CASE #PL2020-112

MINNESOTA
CAMPUS PARKING
RAMP

Name
Date 07-08-2020 Lic./Reg. No. 53706
Issued For
Item Date
CITY SUBMITTAL 07-08-2020

CIVIL DETAILS

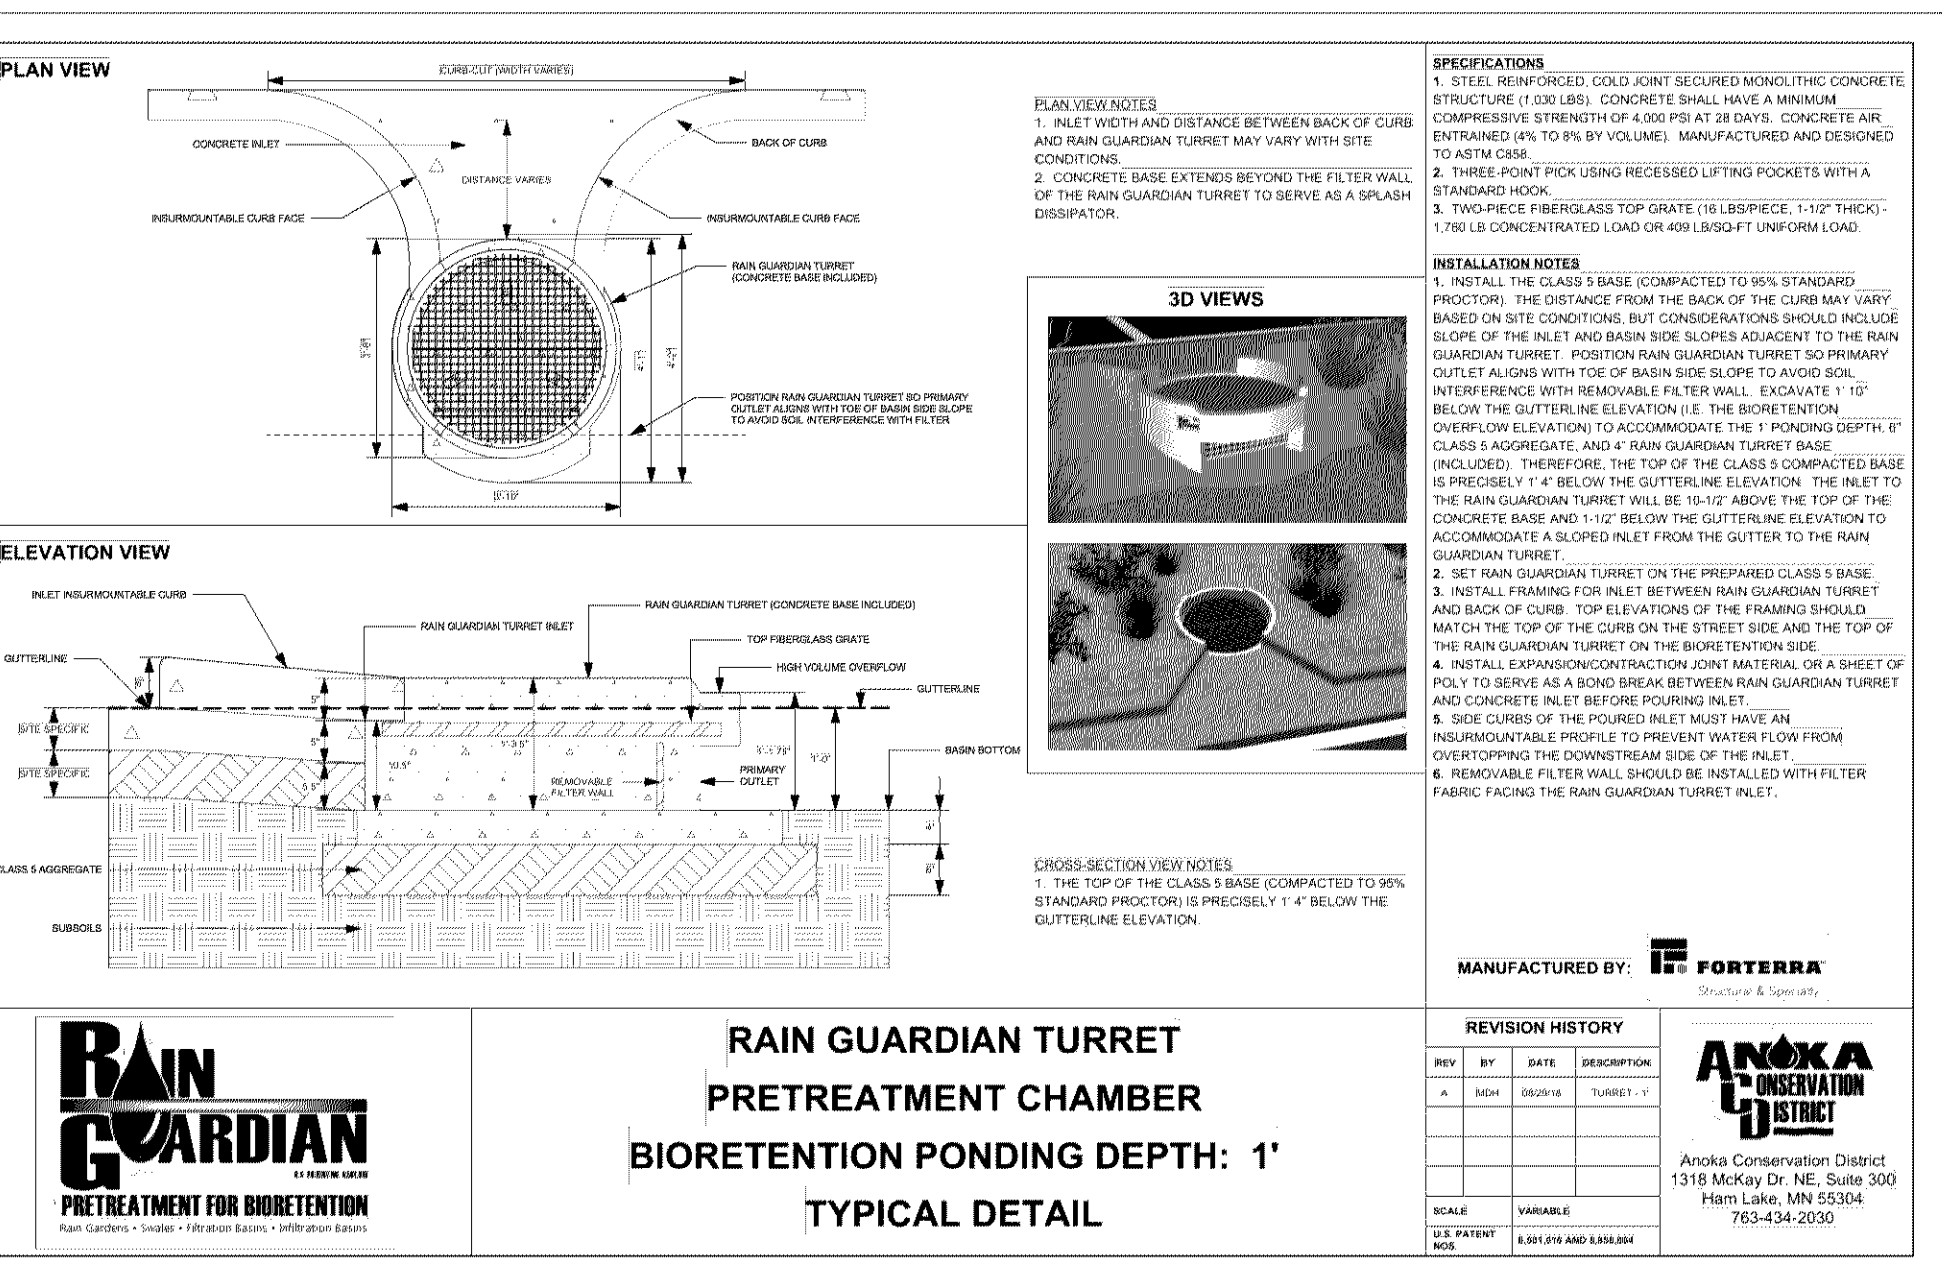
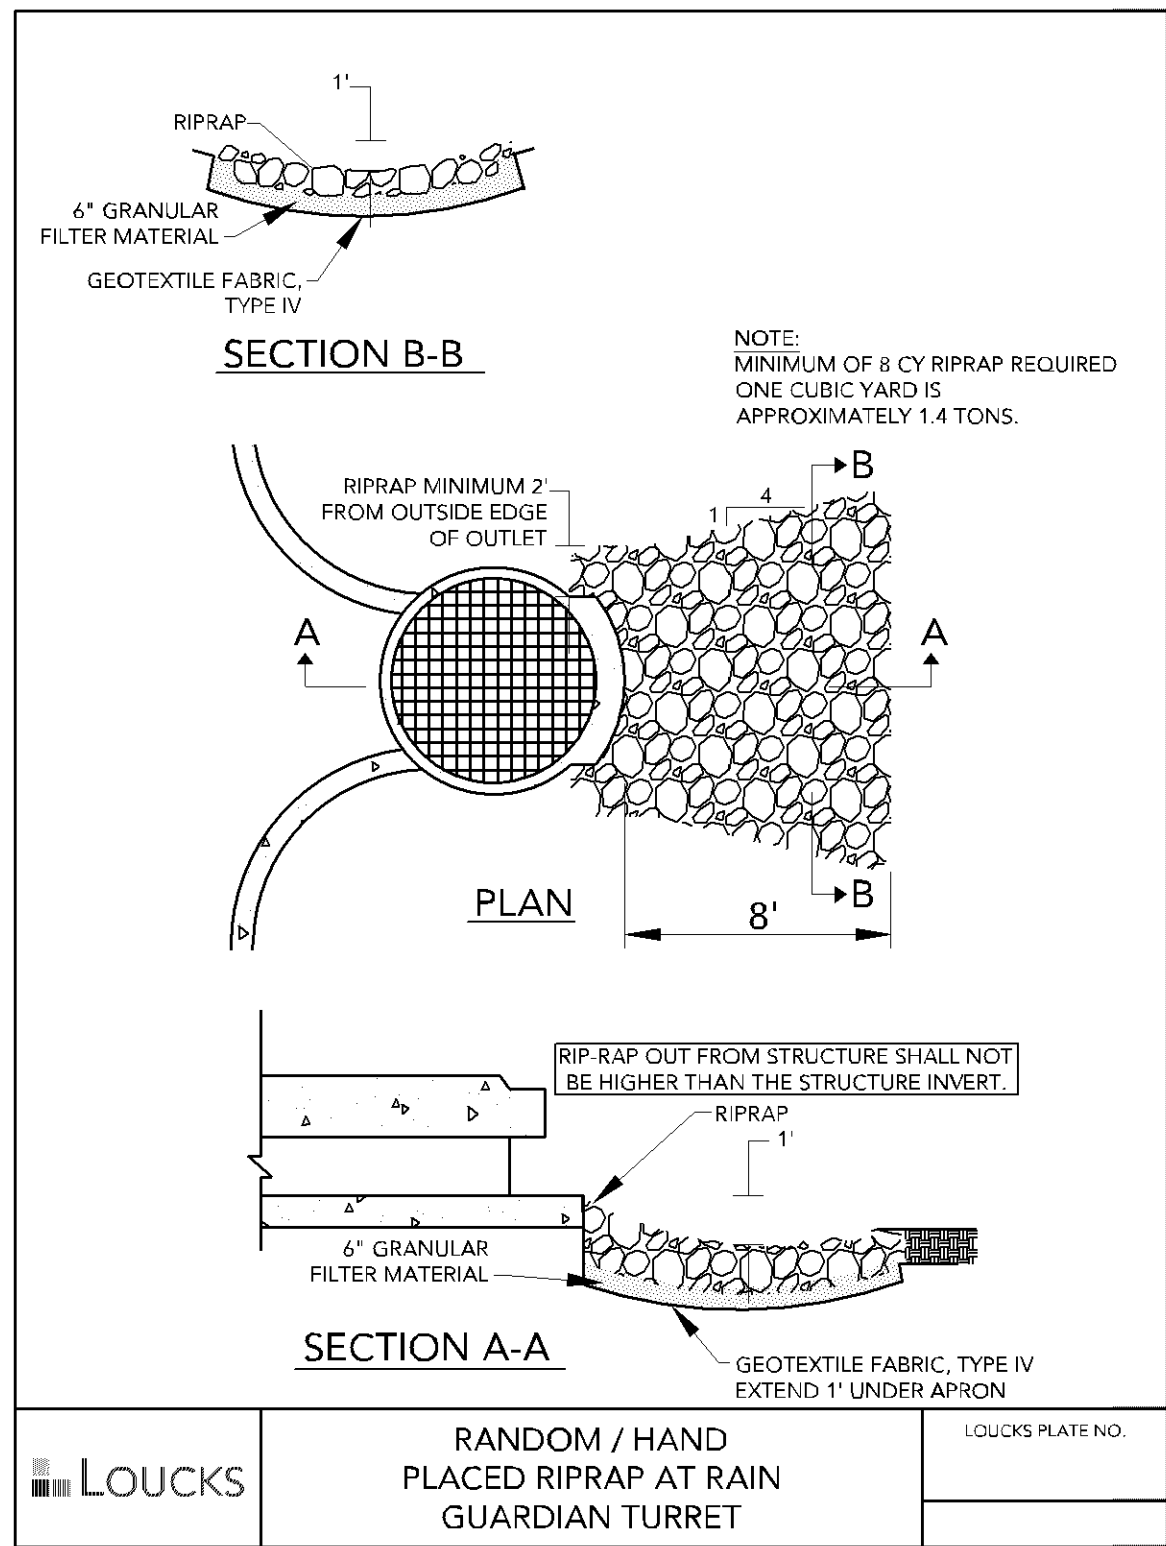
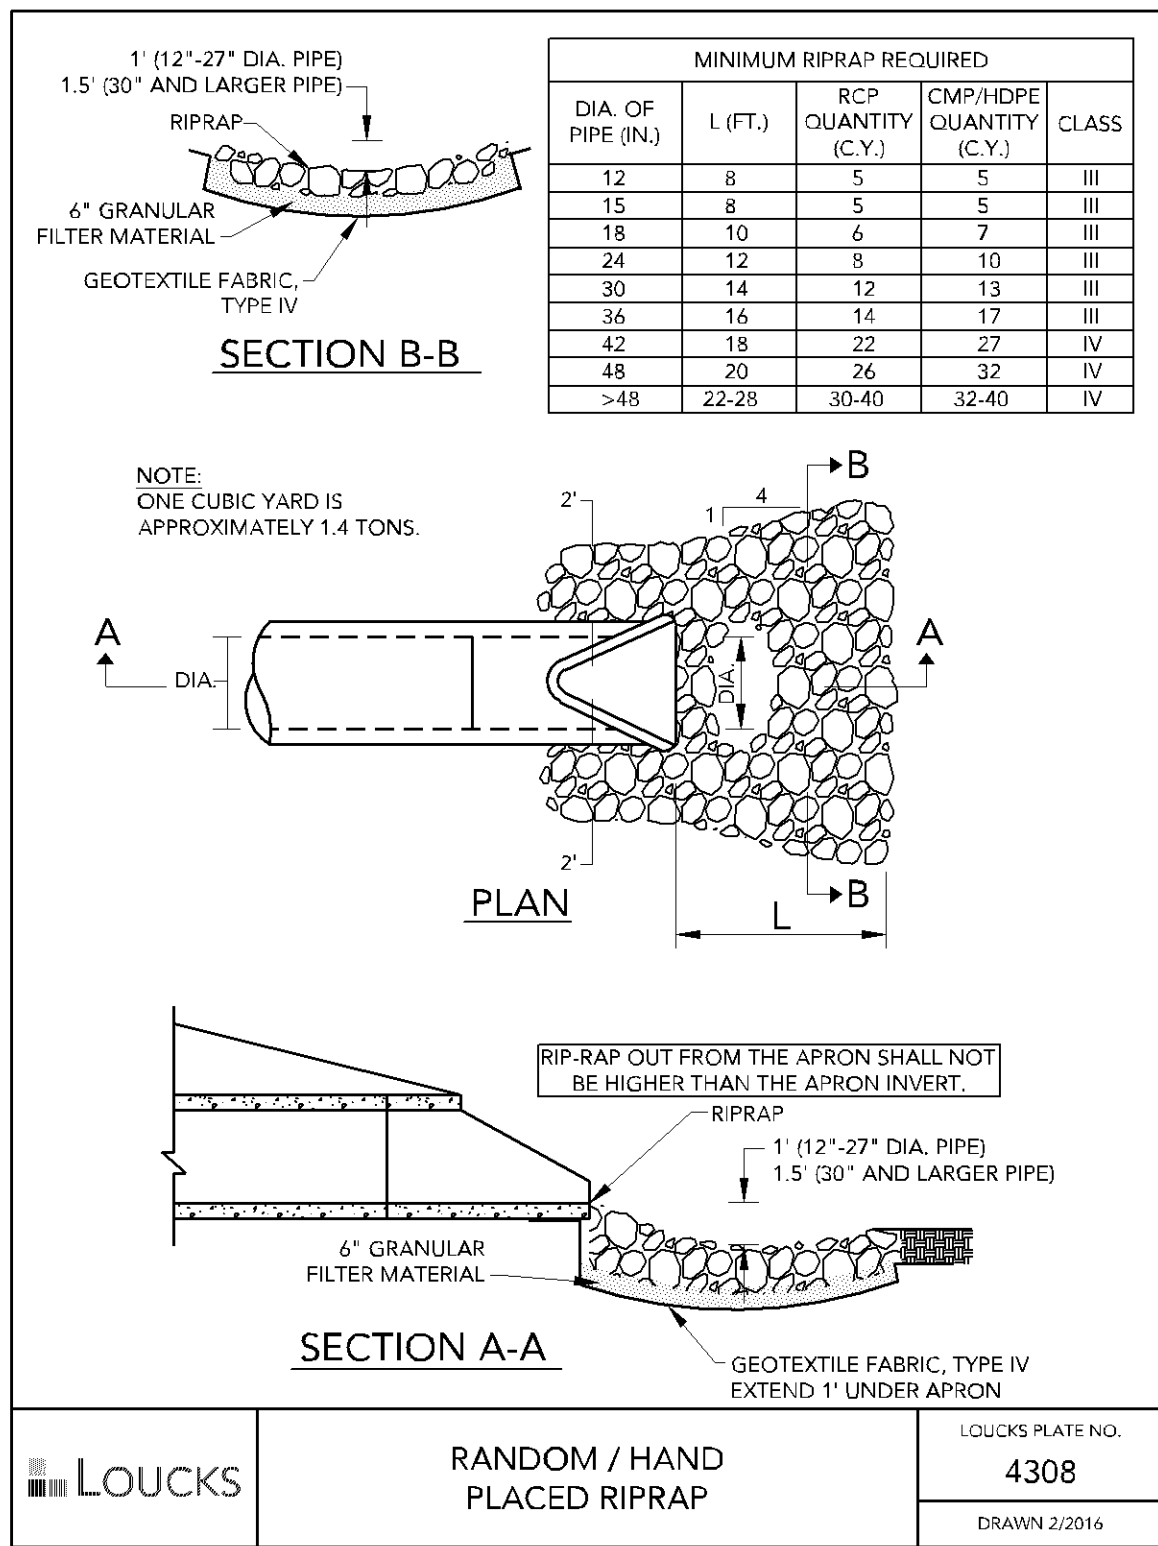
Provide thrust block detail, see City website
